Changes from P0

Title: UI V3A

Rev: P1
Id: 1/1

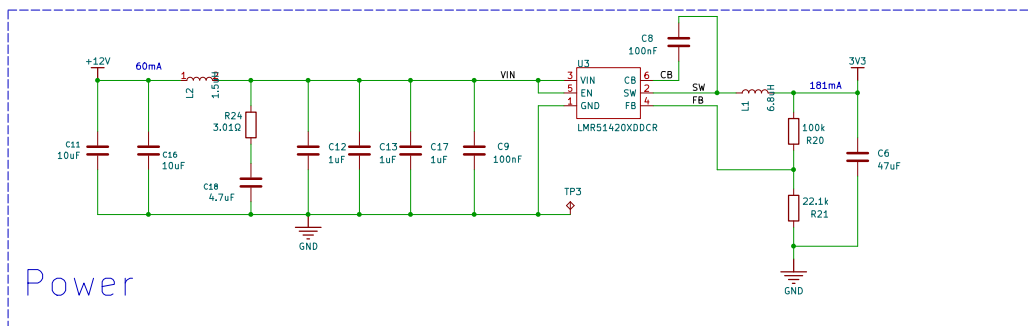
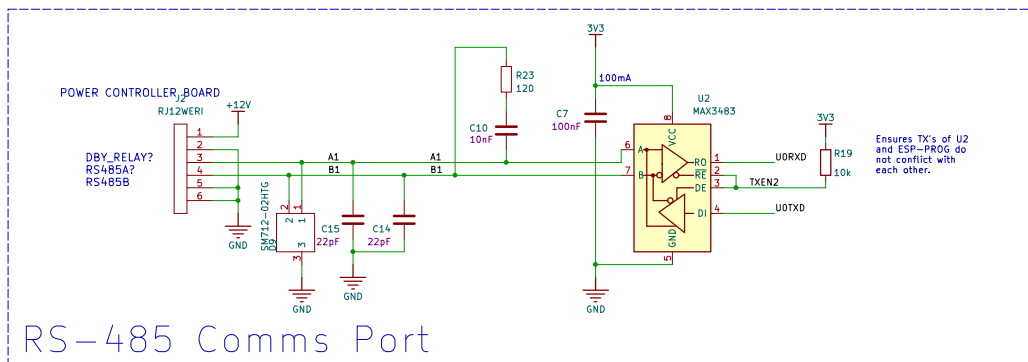
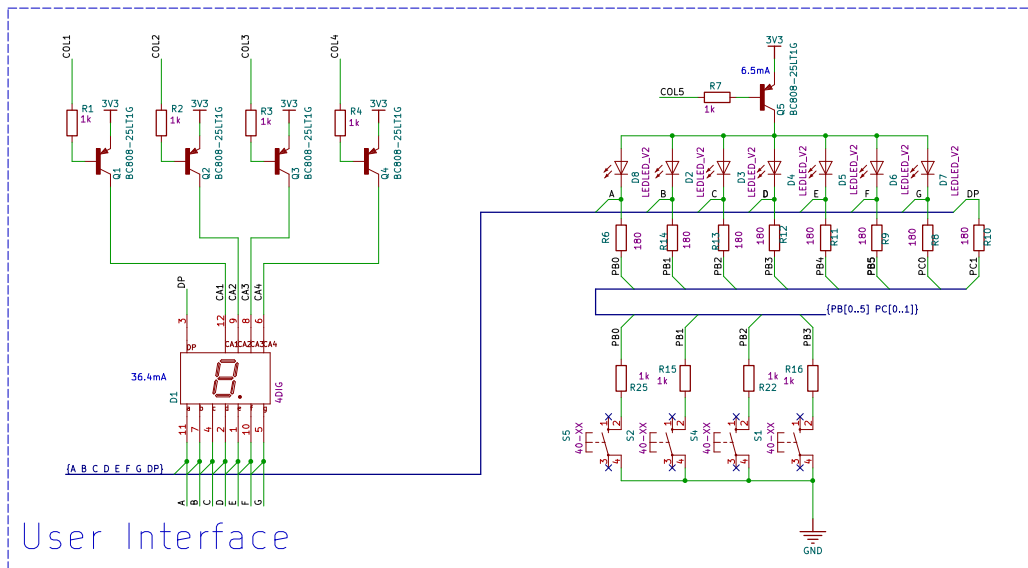
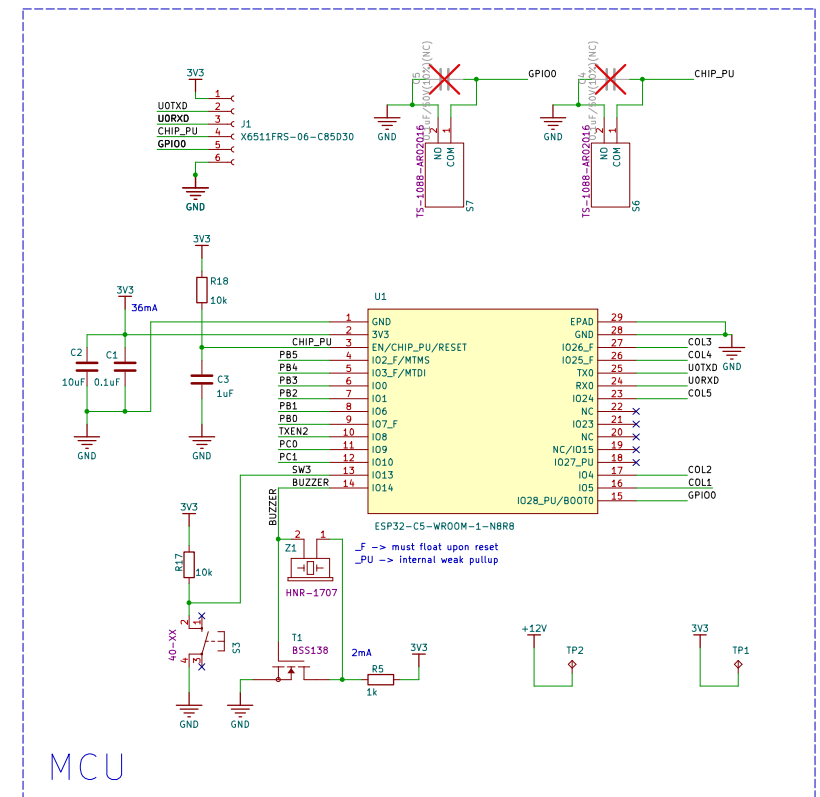
1. removed auto-programming circuit
2. put back GPIO push button
3. Dev version has blue LED. Unmount in Prod version –DONE
4. Corrected ESP32–C5 symbol
5. Removed C15 and C17 in P0 schematic that messes with RS–485 comms
6. In LMR54120 feedback, changed 162k to 100k to get 3.3V so that 5V supply is no longer needed
7. Changed MAX483 to its 3.3V version, MAX3483
8. Used 0603 package where hand-soldering may be required.
9. Followed the 15mm clearance rule around ESP32–C5 PCB antenna
10. Included DCDC input and output filtering.
